**TSG-RAN Meeting #12
Stockholm, Sweden, 12 - 15 June 2001**

RP-010359

Title: Agreed CRs (Release 4) to TS 25.102

Source: TSG-RAN WG4

Figure A.2A

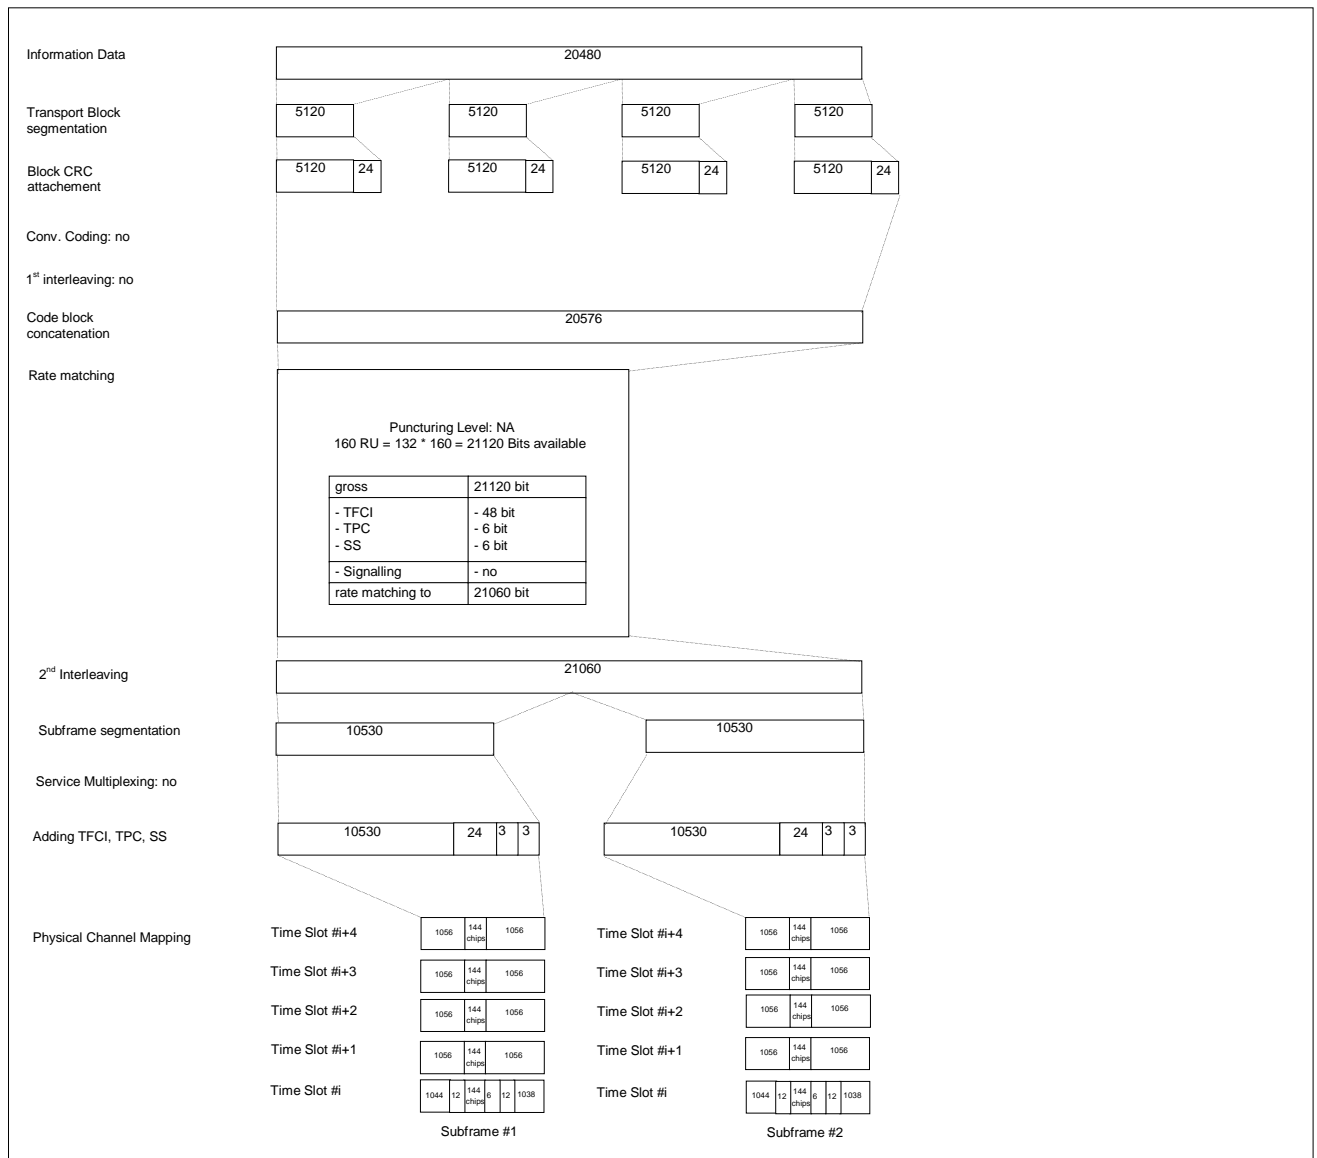
Reason for change:	⌘ WG1 technical report, TR25.928, has specified the 2Mbit/sec downlink channel for 1.28 Mcps TDD Option. This is not included as reference measurement channel in the current TS25.102 specification.
Summary of change:	⌘ Service mapping for 2Mbit/sec downlink channel for 1.28 Mcps TDD Option is added.
Consequences if not approved:	⌘ Test conditions are incomplete.

A.2.8.2 1.28 Mcps TDD Option

Parameter	Value
Information data rate	2048 kbps
RU's allocated	5TS (1*SF1) = 80RU/5ms
Midamble	144
Interleaving	10 ms
Power control (TPC)	6 Bit/user/10ms
TFCI	48 Bit/user/10ms
Synchronisation Shift (SS)	6 Bit/user/10ms
Inband signalling DCCH	no
Coding	no
Modulation	8PSK

Figure A.6A

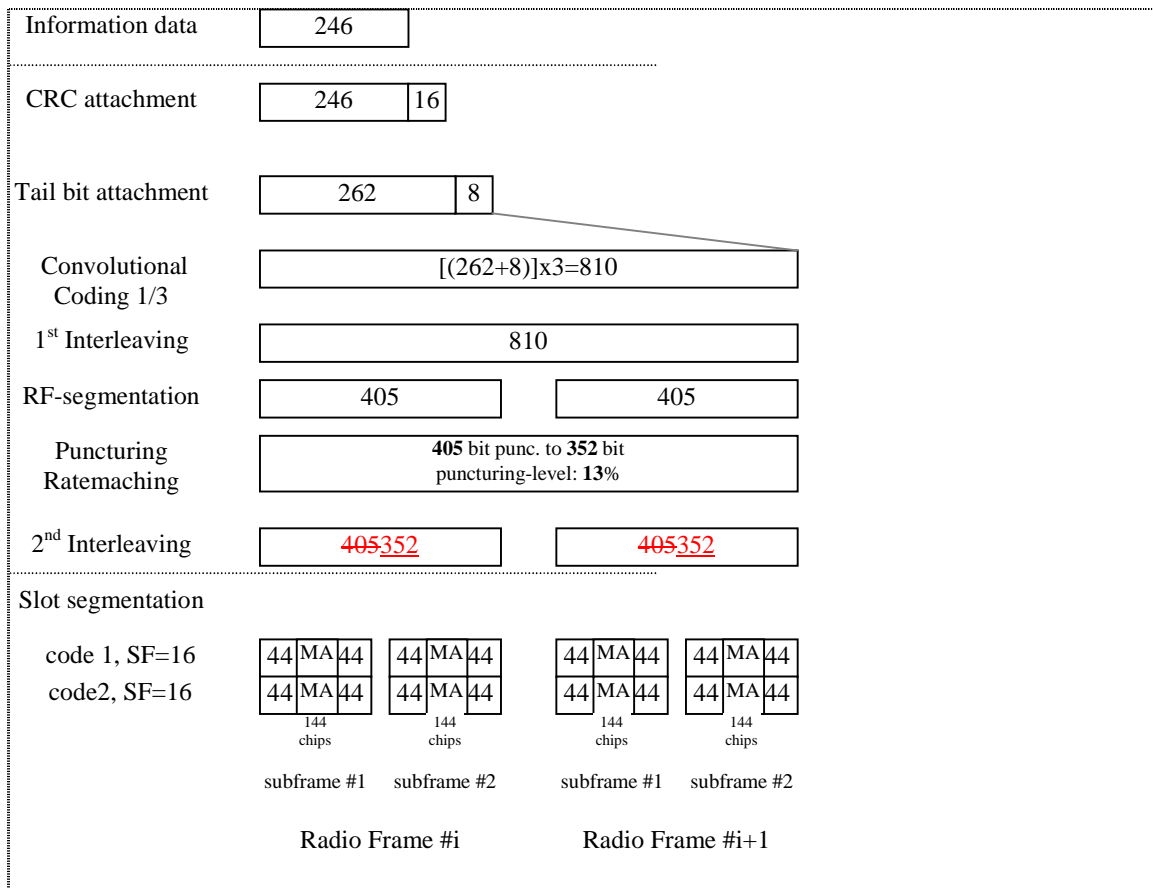
Reason for change:	⌘ Incorrect values after 2 nd interleaving in BCH measurement channel description for 1.28 Mcps TDD option
Summary of change:	⌘ Numbers in row 2 nd Interleaving corrected
Consequences if not approved:	⌘ Incorrect values

A.2.6.2 1.28 Mcps TDD Option

Parameter	Value
Information data rate:	12.3 kbps
RU's allocated	2 RU
Midamble	144 chips
Interleaving	20 ms
Power control	0 bit
TFCI	0 bit
Puncturing level	13%

Figure 6.1B. Conditions for out-of-synch handling in the UE - discontinuous transmission. The indicated thresholds Q_{sbout} and Q_{sbin} are only informative.

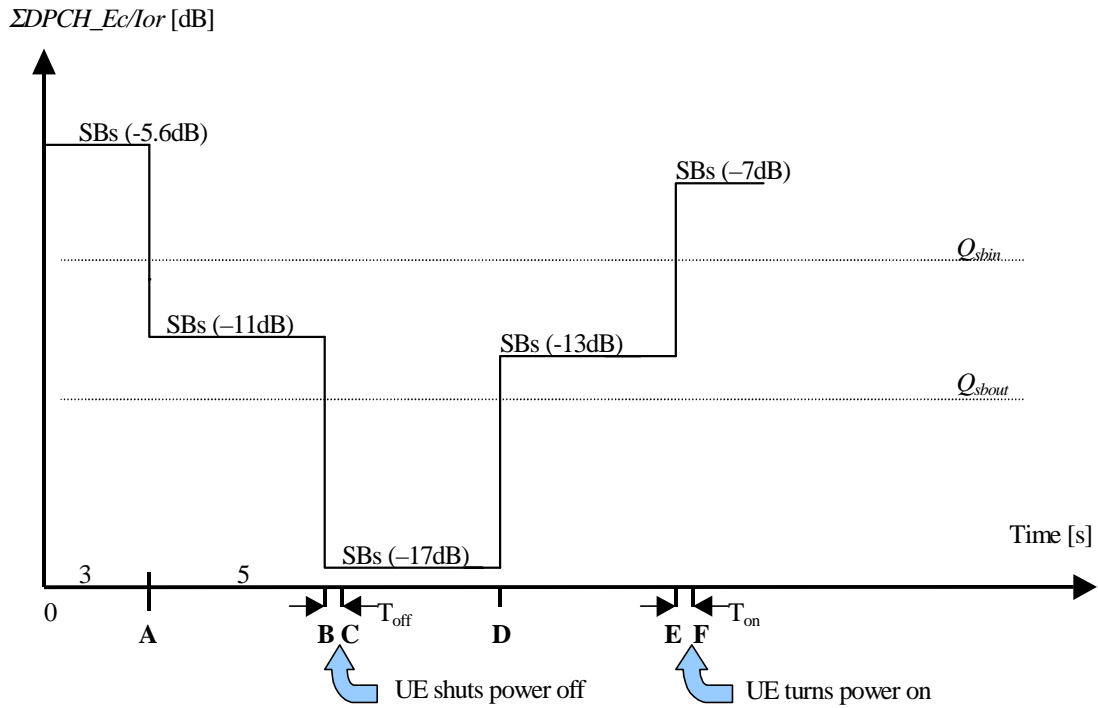
Reason for change:	⌘ WG1 Specification, TS25.224, has specified procedures for use of Special Bursts during DTX and has clarified the processing of these bursts to support Out-of-Sync Handling of output power. In prior version the test conditions used when testing the UE transmit power requirements did not include DTX for 1.28 Mcps TDD Option.
Summary of change:	⌘ Include DTX in the test conditions for 1.28 Mcps TDD Option when testing UE transmit power requirements.
Consequences if not approved:	⌘ Test conditions are incomplete.

The DCH parameters are shown in Table 6.4B.

Parameter	Unit	Value
\hat{I}_{or}/I_{oc}	dB	-1
I_{oc}	dBm/3.84 MHz	-60
$\frac{\Sigma DPCH_E_c}{I_{or}}$	dB	See figure 6.1B
Bits/burst (including TFCI bits)	bits	88 in each subframe
TFCI	-	On

During the period of 3 frames with no data, the UE will receive a very low power, which is not shown in the figure. In the fourth frame the Special Burst will be sent in both subframes designated to carry the Special Burst during DTX. The power shown in the figure is the power of the Special Burst (which is 3dB lower than power for normal data, which is shown in Figure 6.1B).

The requirements for the UE are that:

The UE shall not shut its transmitter off before point B.

The UE shall shut its transmitter off before point C, which is $T_{off} = 200$ ms after point B.

The UE shall not turn its transmitter on between points C and E.

The UE shall turn its transmitter on before point F, which is $T_{on} = 200$ ms after Point E.
